S307-03

TECHNICAL BULLETIN

DTC P0741 –
Torque Converter Clutch Does Not Lock Up –
Missing Seal Ring

MODEL 2000-02 MY
S-TYPE
VIN L00001-M44997

ILLUSTRATION 1

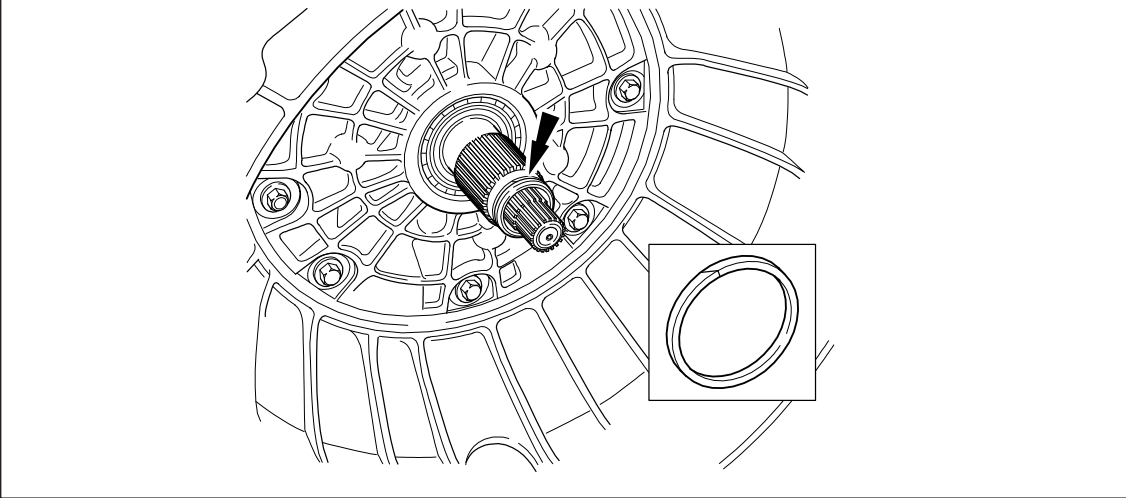
3. Inspect the stator shaft and determine if the seal is damaged or if no seal is present at the location shown in illustration 1.

4. If no transmission input shaft seal is installed, install a new seal.
5. Install the transmission torque converter.
6. Install the automatic transmission (see Global Technical Reference GTR Workshop Manual, section: 307-01, SRO 44.20.01).
7. Use WDS to carry out a transmission fluid level check (see Global Technical Reference GTR Workshop Manual, section: 307-01, General Procedures).
8. With WDS already connected, clear all DTCs from the Transmission Control Module (TCM).
